<p align="center">Village of Esperance</p> <p>Maps available for inspection at the Esperance Village Hall, Church Street, Esperance, New York.</p>		<i>Mitigation Division Director, Emergency Preparedness and Response Directorate.</i>	
<p align="center">Town of Fulton</p> <p>Maps available for inspection at the Fulton Town Office, 1168 Bear Ladder Road, West Fulton, New York.</p>		[FR Doc. 03-29796 Filed 11-28-03; 8:45 am]	
<p align="center">Town of Middleburgh</p> <p>Maps available for inspection at the Middleburgh Town Hall, 146 Railroad Avenue, Middleburgh, New York.</p>		BILLING CODE 6718-04-P	
<p align="center">Village of Middleburgh</p> <p>Maps available for inspection at the Middleburgh Village Municipal Building, 309 Main Street, Middleburgh, New York.</p>		DEPARTMENT OF TRANSPORTATION	
		National Highway Traffic Safety Administration	
		49 CFR Parts 571 and 586	
		[Docket No. NHTSA-03-16523]

RIN 2127-AF36	
		Federal Motor Vehicle Safety Standards; Fuel Systems Integrity	
		AGENCY: National Highway Traffic Safety Administration (NHTSA), Department of Transportation (DOT).	
		ACTION: Final rule.	
		SUMMARY: In this document, NHTSA is upgrading the rear impact test in the Fed

FIGURE 3 – MOVING DEFORMABLE BARRIER REAR IMPACT - 70 % OVERLAP

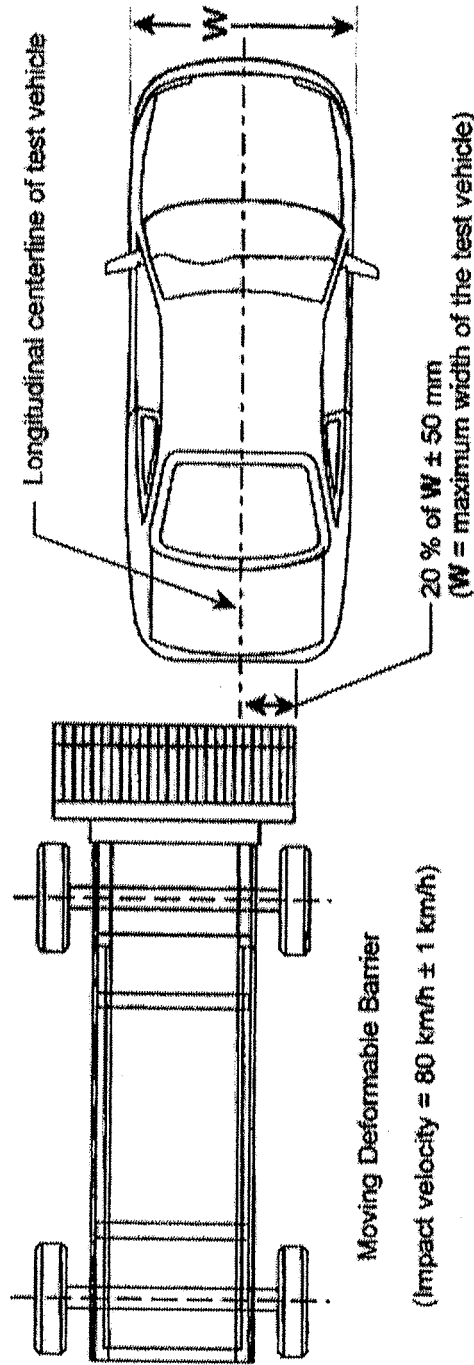
■ 3. In § 571.301, paragraphs S6.2, S6.3, S7.1.6(b), S7.2, and S7.3 are revised, paragraph S8 is added, and Figure 3 is added following Figure 2, to read as follows:

(2) The deformable face of the barrier is mounted on the barrier 50 mm (2 inches) lower than the height from the ground specified in Figure 2 of Standard No. 214 (49 CFR 571.214) (All dimensions from the ground in Figure 2, Front View should be reduced by 50 mm (2 inches.);)

of the vehicle parallel to the line of travel and perpendicular to the barrier face within a tolerance of ± 5 degrees. The test vehicle and barrier face are aligned so that the barrier strikes the rear of the vehicle with 70 percent overlap toward either side of the vehicle. So aligned, the barrier face fully engages one half of the rear of the vehicle and partially engages the other half. At impact, the vehicle's longitudinal centerline is located inboard either of the side edges of the barrier by a distance equal to 20 percent of the vehicle's width ± 50 mm (see Figure 3). The vehicle's width is the maximum dimension measured across the widest part of the vehicle, including bumpers and molding, but excluding such components as exterior mirrors, flexible mud flaps, marker lamps, and dual rear wheel configurations.
